Access Compliance Report Public Rights-of-Way (Curb Ramps)

Main Street: N/A Cross Street: NARROW_CANYON_RD Location: S

ADA ID: RPRK211202122324 Ramp Type: Type 4 - Parallel Initial Pass/Fail: Pass Overall Compliance: No Severity Score: 25

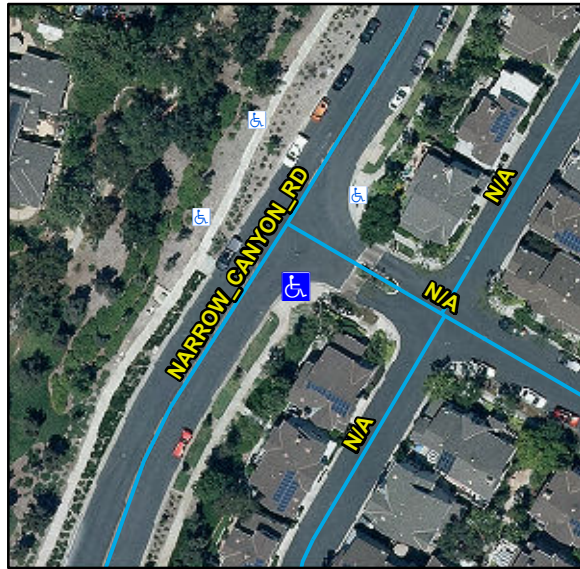
Compliance	Description	Data	Compliance	Description	Data
N/A	Ramp Length LT (in)	128	N/A	Ramp Length RT (in)	128
Yes	Ramp Width LT (in)	92	Yes	Ramp Width RT (in)	93
Yes	Ramp Run Slope LT (%)	7.7	Yes	Ramp Run Slope RT (%)	1.6
Yes	Ramp Cross Slope LT (%)	0.4	Yes	Ramp Cross Slope RT (%)	1.4
N/A	Landing Present	No	No	DWS Provided	No
N/A	Landing Length (in)	N/A	N/A	DWS Contrast	N/A
No	Landing Width (in)	N/A	N/A	DWS Length (in)	N/A
No	Landing Run Slope (%)	N/A	N/A	DWS Full Width	N/A
No	Landing Cross Slope (%)	N/A		DWS Offset Type	N/A
N/A	Landing Movement Obstructed?	No	N/A	DWS Offset Left (in)	N/A
	Landing Movement Type	Curb	N/A	DWS Offset Right (in)	N/A
N/A	Landing Shared	N/A			
N/A	Clear Space	Yes			
N/A	Clear Space To Crosswalk (in)	48			
N/A	Marked Crosswalk 1	No	N/A	Marked Crosswalk 2	No
	Crossing 1 Direction	NE		Crossing 2 Direction	NW
N/A	Marked Crosswalk 1 Width (in)	N/A		Marked Crosswalk 2 Width (in)	N/A

N/A	Ramp Inside Crosswalk 1	N/A	N/A	Ramp Inside Crosswalk 2	N/A
	Crossing 1 Slope (%)	2.8		Crossing 2 Slope (%)	3.8
	Crossing 1 Cross Slope (%)	1.6		Crossing 2 Cross Slope (%)	2.7
Yes	Gutter Ponding	No	No	Curb Slope	14.1
Yes	Gutter Lip Height (in)	0		Road Run Slope (%)	2.2
No	Gutter Run Slope (%)	10.3		Road Cross Slope (%)	4
No	Gutter Cross Slope (%)	2.3	No	Perpendicular Joint Present	No
Yes	Overall Surface Condition	Acceptable			
	Cross Gutter Present?	No		Spandrel Present?	No
	Replace Cross Gutter?	N/A		Replace Spandrel?	N/A

Remove & Replace Curb Ramp With Two New Directional Ramps or Equivalent. Remove & Replace Gutter.
